**Re: Planning and Development Acts 2000-2014
Planning & Development Regulations 2001-2013 (Part VIII)
Mungret Environs Road Works**

**PLANNING REPORT IN ACCORDANCE WITH
SECTION 179 3(a) OF THE PLANNING AND
DEVELOPMENT ACT 2000 - 2014**

Re: Mungret Environs Roadworks, which includes improvements to the existing road infrastructure in the environs of Mungret, as well as a new section of distributor road with a new roundabout to facilitate possible new school developments in this area. The retro fit of the existing road network will involve new footpaths, cycle ways, pedestrian crossings, public lighting, road widening, set-down areas and shared surfaces. The works will also include for a new section of distributor road south of the R859 linking to Moore's Lane. The proposed scheme will also involve the provision of two new signalised junctions at the junctions of the L-1438 with the N69 and R859 (part of the works are within the curtilage of a Protected Structure) - Planning Reference No: 15/8006

Project: Road Schemes 2015
 Title: Accommodation Works agreement for Vicki Grima / Wayne Buckley Mount Mungret
 Date: 11/06/2015
 Drawn: P.J. Kennedy
 Checked: Robert Callaghan
 Date: 11/14/01-012 N/A

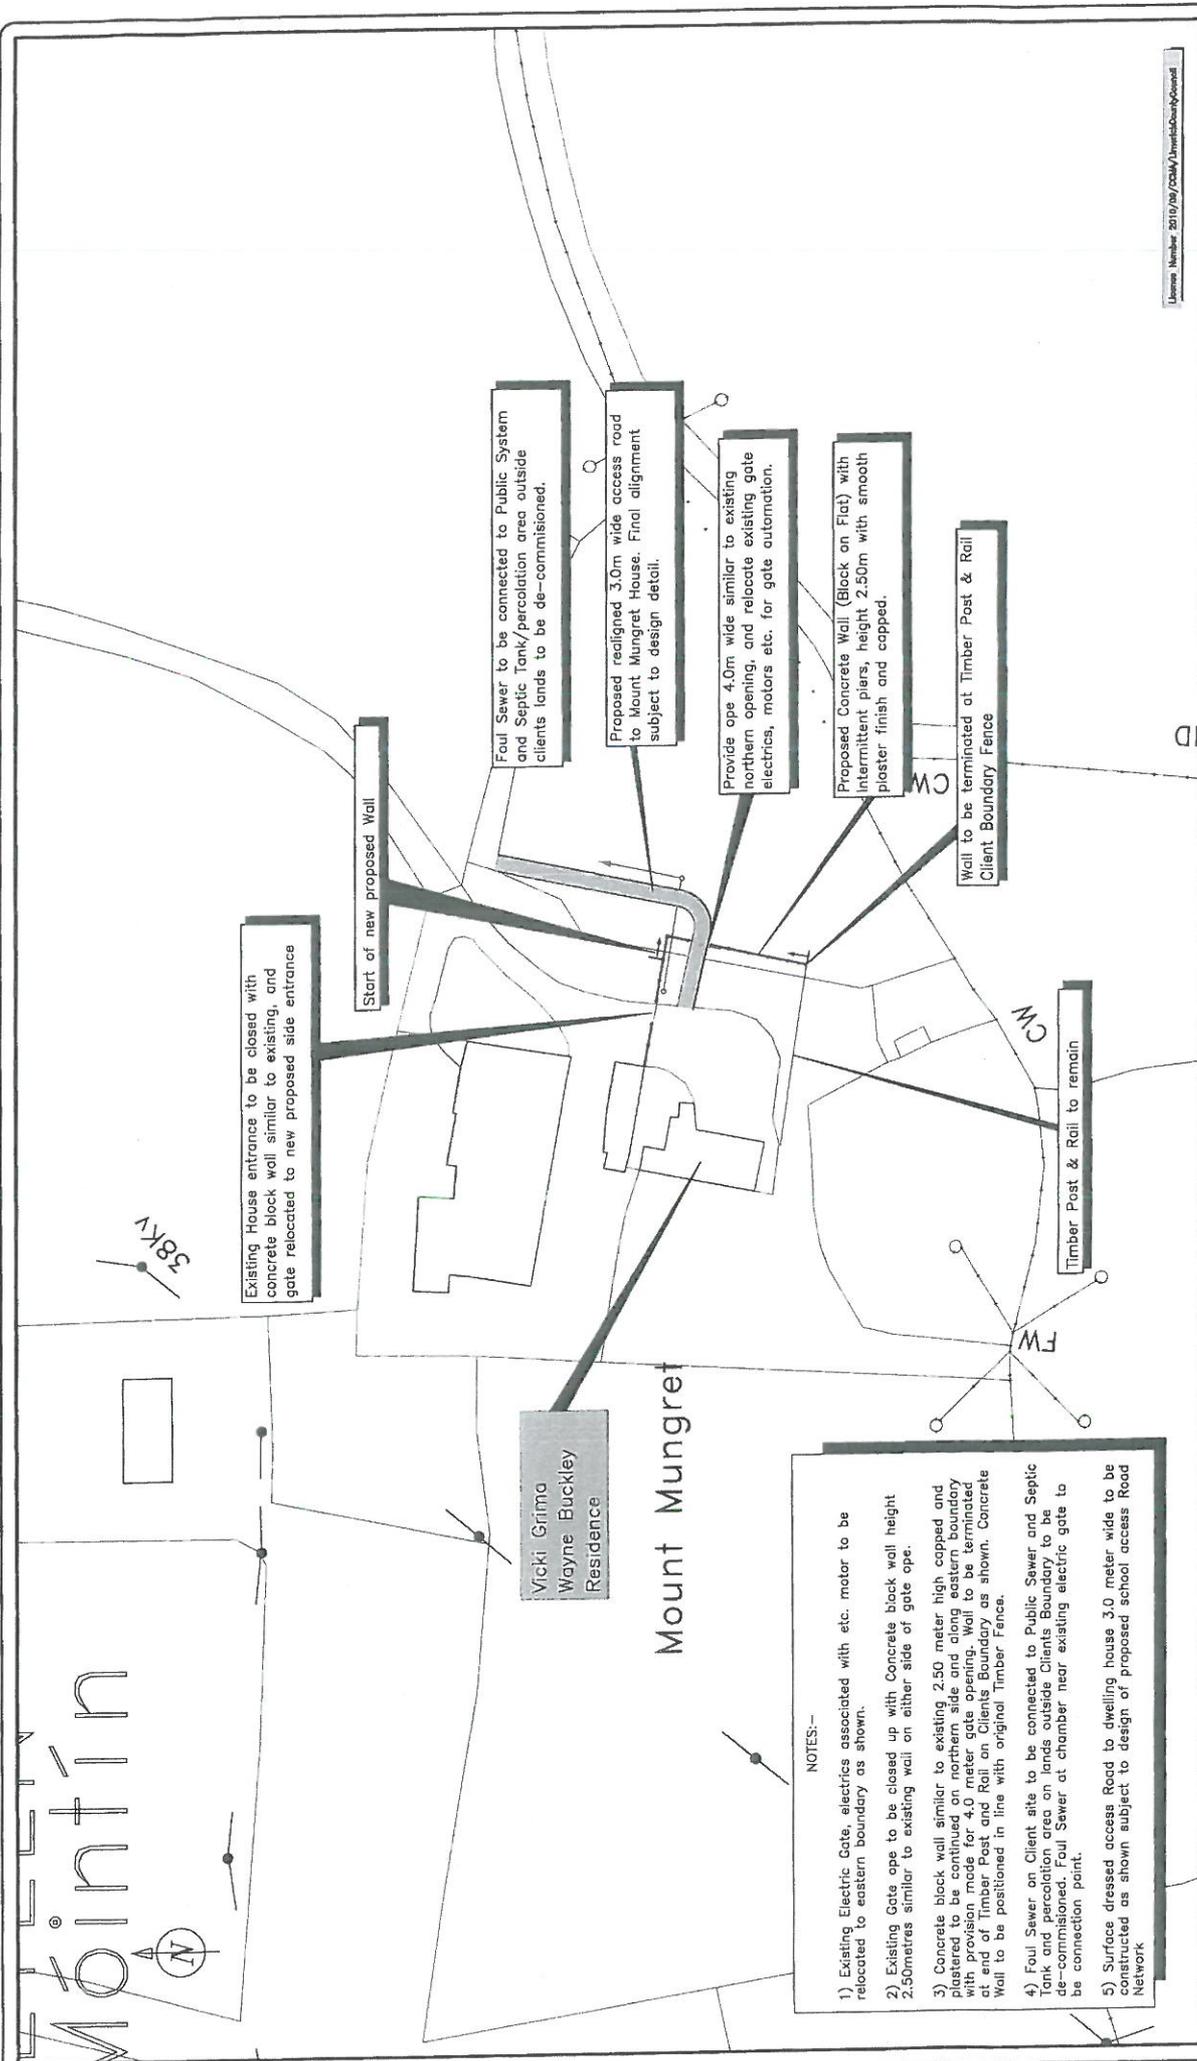
SUB (H) Vicki Grima and Wayne Buckley, Mount Mungret House, Mungret, Co. Limerick

The submission received on the 23rd June 2015, indicates that the above live in a recently purchased house immediately south of Atlantic Cabins and currently share a right-of-way entrance with the latter. Their submission raises concerns on access, traffic, pollution, lighting, dust and security. It points out that they currently reside in a quiet rural setting which will be transformed completely under the proposed road works.

Numerous meetings and discussions have take place with Wayne Buckley. A segregated access is proposed for this private house, together with other accommodation works detailed in the accompanying drawing, chief of which is a front boundary wall which will provide both a visual and a noise barrier from the new road. Sewage and water supply accommodation is proposed. A drawing (Drawing No. 11/147/01 - 012) of proposed accommodation works has been prepared as a basis of addressing the concerns and is attached as proposed works under the road scheme.

Existing House entrance to be closed with concrete block wall similar to existing, and gate relocated to new proposed side entrance

Proposed realigned 3.0m wide access road to Mount Mungret House. Final alignment subject to design detail.

Provide ope 4.0m wide similar to existing northern opening, and relocate existing gate electrics, motors etc. for gate automation.

Proposed Concrete Wall (Block on Flat) with intermittent piers, height 2.50m with smooth plaster finish and copped.

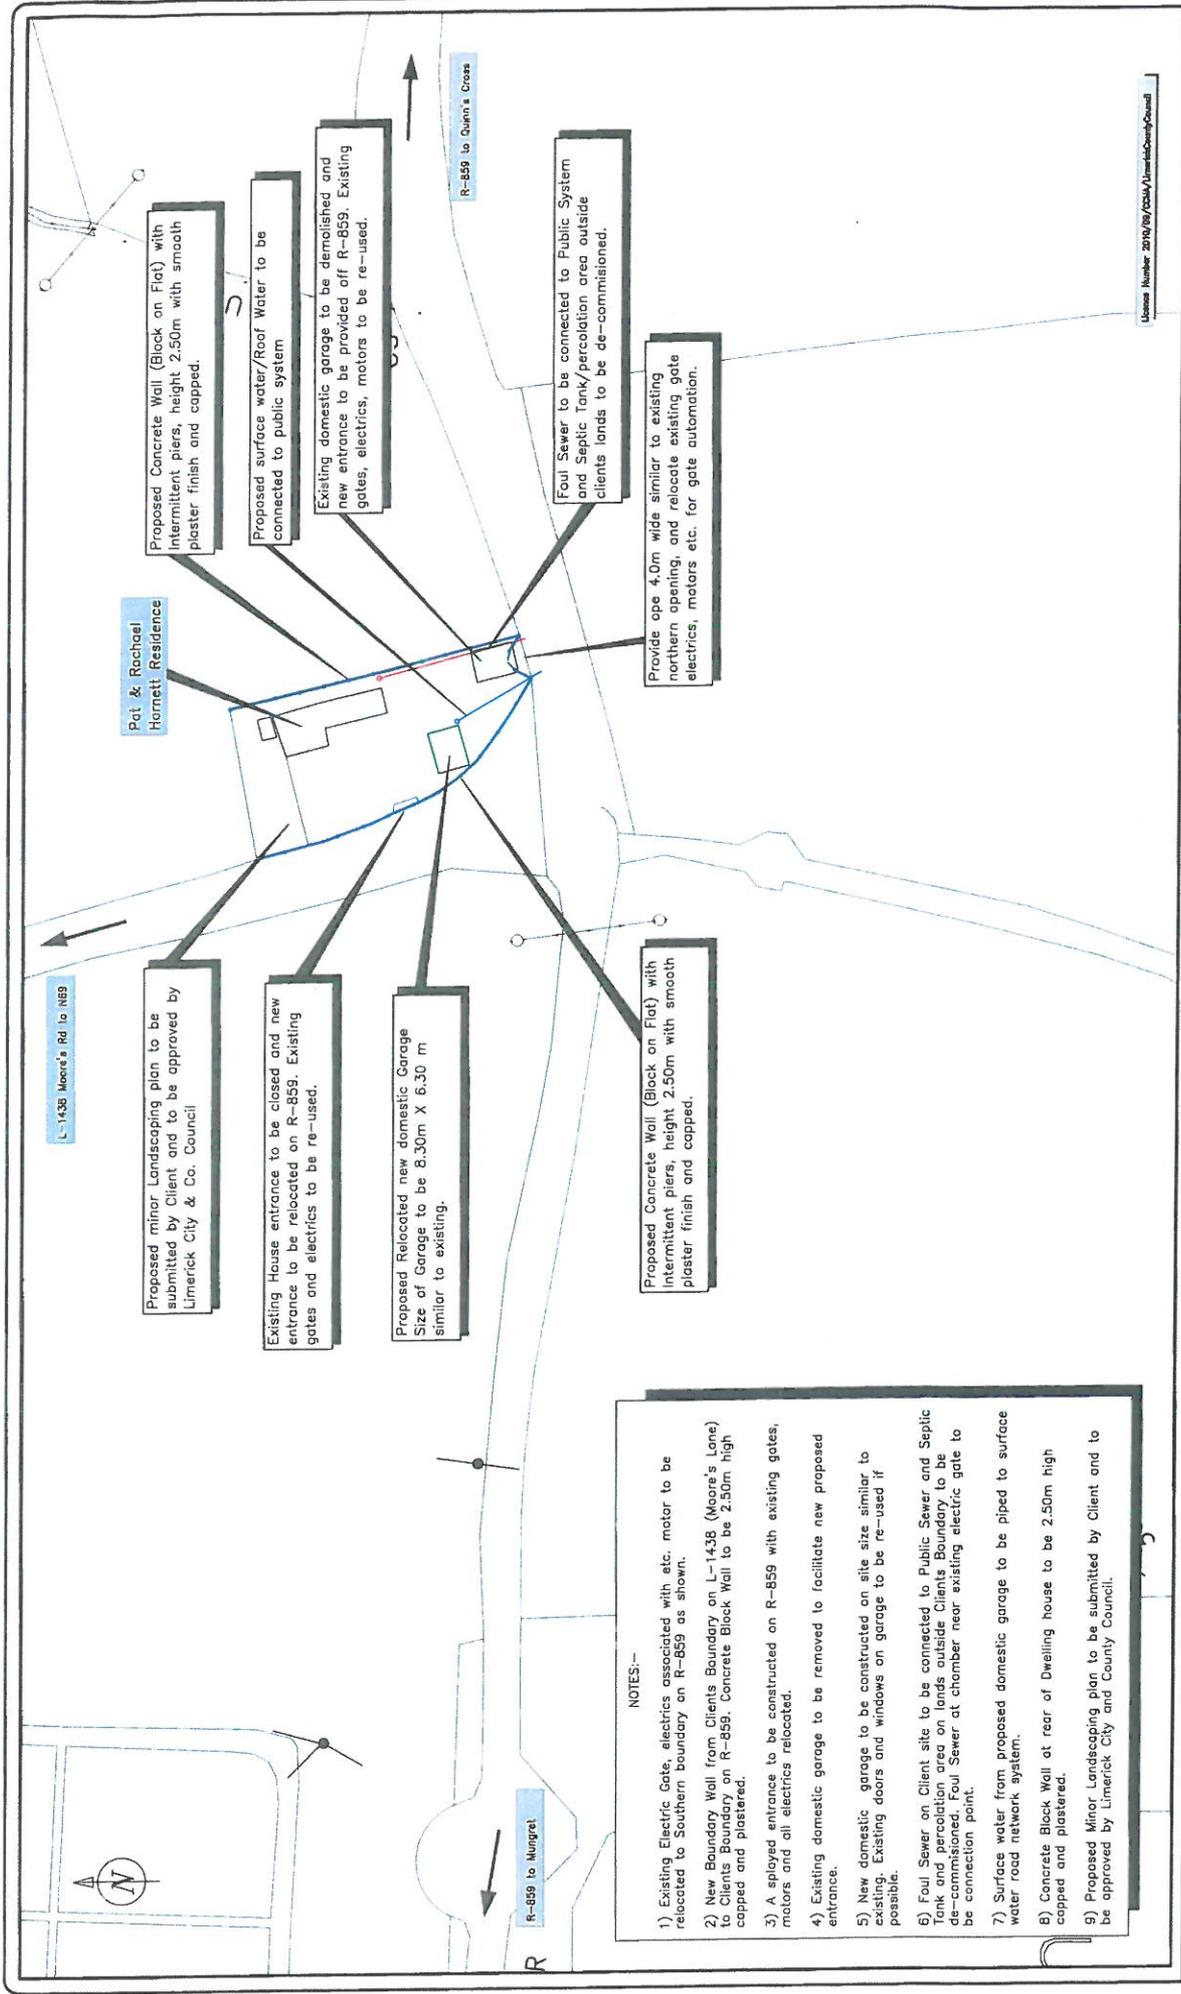
The submission received on the 19th of May 2015, Atlantic Cabins & Containers Ltd. outline concerns with regard to the proposed development, given the location of their commercial property, concerns includes: increase traffic volumes, noise, light, debris/rubbish, dust, privacy and security, drainage and construction works. The above party outline that they have been operating from the site for the last 11 years and have 8 people employed. They also have part of their premises let to Kirby Electrical for the storage of cables and components. Particular concerns highlighted in addition to the above include: construction works and compatibility of their use at this location.

The Travel & Transport Department have met with Mr Curtin, the owner of the premises. A new access off the turning distributor road access is proposed, with segregated access from the adjoining private house, along with security fencing, site clearance sewage/water supply facilities. A drawing (Drawing No. 11/147/01 – 013) of the proposed accommodation works is attached as proposed works under the road scheme.

Atlantic Cabins will be given a new entrance from the turning roundabout on the school access road. The existing entrance will be closed. Proper traffic management measures, as proposed in the Part VIII, will help to manage the increased traffic, appropriate to urban standards.

- NOTES:-**
- 1) Access Road 6.0m wide from Proposed Roundabout to Northern access gate of Atlantic Cabins.
 - 2) A 2.50 meter high security gate 4.0 meters wide to be provided at entrance to Atlantic Cabins premises.

- 3) A 2.50 meter high, 4.0 meter wide gate to be provided for future access to Limerick City & Co Council Lands / proposed GAA Lands.
 - 3) A Palisade security fence to be provided on Western, Northern and Eastern boundaries as shown.
